Project Name & Applicant Team:	
<u>Applicant:</u>	Ditto Residential, 2217 14 th Street NW, Suite 300, Washington, DC 20009 Attn: Jamie Weinbaum (202-285-3967/ jamie@dittodc.com)
<u>Land Use Counsel:</u>	Holland & Knight, 800 17 th Street NW, Suite 1100, Washington, DC 20006 Attn: Chip Glasgow (202-419-2460/ norman.glasgowjr@hklaw.com)
<u>Transportation Consultants:</u>	Gorove/Slade Associates, Inc., 1140 Connecticut Avenue NW, Suite 600, Washington, DC 20036 Attn: Erwin Andres (202-540-1925/ ena@goroveslade.com); Jim Watson (202-296-8628/ jww@goroveslade.com)
Case Type & No. (PUD, LTR, etc.):	PUD
Street Address:	301 Florida Avenue NE, Washington, DC 20002
Current Zoning and/or Overlay District:	C-M-1
Date of Filing:	Spring 2015
Estimated Date of Hearing:	Summer-Fall 2015
Description of Project:	The 301 Florida Avenue NE PUD site is located in a triangular block bounded by Florida Avenue to the north, N Street to the south, and Third Street to the west, as shown in Figure 1. The site is located approximately 800 feet from the north portal of the NoMa Gallaudet Metro Station and approximately 1,000 feet from the south portal of the station. Robust bus service also exists along Florid

Figure 2: Site Plan

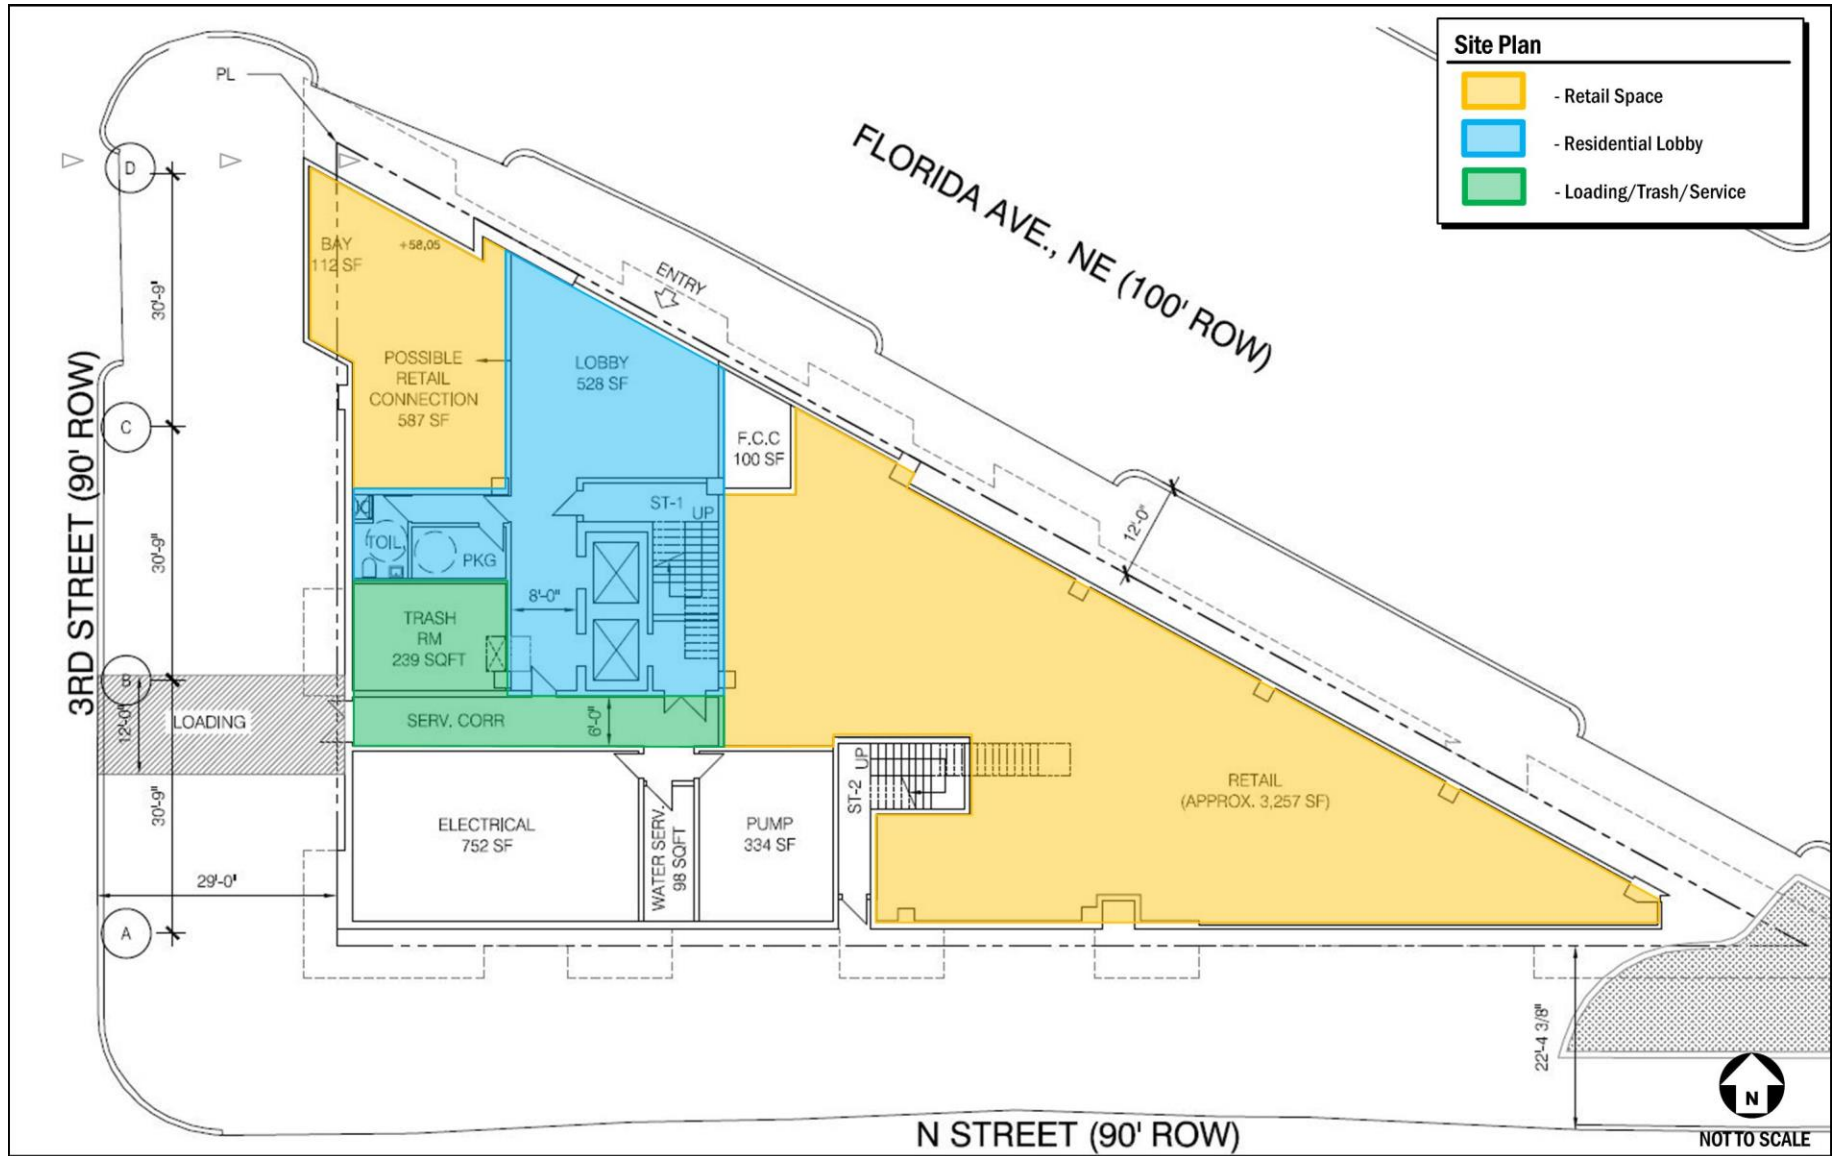
<p><u>Vehicle Site Access</u></p> <p>Guidelines: If vehicle access is needed, at a minimum the CTR will provide locations of access point(s) and desired access controls (full, right-in/right-out, etc.). See Section 3.2.2 of the CTR guidelines for any further requirements.</p> <p>The proposed site plan is shown in Figure 2.</p> <p>Access Location(s): Since no parking will be provided, no vehicular access will be provided to the site. Loading access is planned to be curbside from Third Street.</p> <p>Access Control: N/A</p> <p>Existing Curb cuts utilized: No existing curb cuts will be utilized for the site.</p> <p>Existing curb cuts abandoned: Three curb cuts will be abandoned along Florida Avenue and one curb cut will be abandoned along Third Street. There is a newly constructed curb along N Street, which effectively closes access to the site from N Street. The site was previously served by a very large open curb cut from N Street,</p>	<p>Plan proposes to close all existing curb cuts around the site. This will provide opportunities to add green space and trees especially along Florida Avenue. UFA supports closing the curb cuts and encourages the</p>

<p>Guidelines: At a minimum, the Applicant is required to show site access for vehicles, pedestrians, and bicyclists. In addition, DDOT has additional policies for site access and loading as they relate to public space. See Section 3.5 of the CTR guidelines for additional information regarding these policies.</p> <p>Freight\Delivery The study will identify existing and proposed commercial vehicle access to the site. See Section 3.5.1 of the CTR guidelines.</p> <p>Motorcoach For developments that will generate significant tourist activity (hotels, museums, etc.) the study will discuss the site plan’s accommodation of motorcoach access. See Section 3.5.2 of the CTR guidelines.</p> <p>Proposed Loading Analysis: Loading for the site will be accommodated curbside from Third Street. Maneuvers into and out of the curb lane along Third Street will be included in the report. A discussion of trash pick-up operations will also be included.</p> <p>This site is not expected to attract Motorcoaches, so no Motorcoach analyses will be conducted.</p>	<p>Note that curbside loading zones are not granted for residential loading or trash/recycling. Additionally, a commercial loading zone is not warranted in this area.</p> <p>Residents will need to get a public space permits for their moving truck for move-in/move-out the. The permit should be for 3rd Street NE.</p> <p>DDOT prefers trash/recycling be handled on N Street NE. The trash/recycling can be moved out of the door provided on 3rd Street and wheeled to N Street where it can be picked up by the trash and recycling provider. This is DDOT’s preferred option as N Street is not a through street and does and will have lower traffic volume.</p> <p>Access to/from the trash/recycling room must be provided for all uses in the building.</p> <p>DDOT recognizes loading is not required for the commercial use in this building however, deliveries will be generated by this use. DDOT expects the Applicant (and future tenant) to accommodate retail deliveries on N Street NE.</p> <p>Please provide a loading management plan to establish procedures for residential move-in/move out, residential and retail trash, and retail deliveries.</p> <p>Please remove the area marked “Loading” on the site plan (Figure 2). This is misleading as not on-site loading zone is proposed.</p>
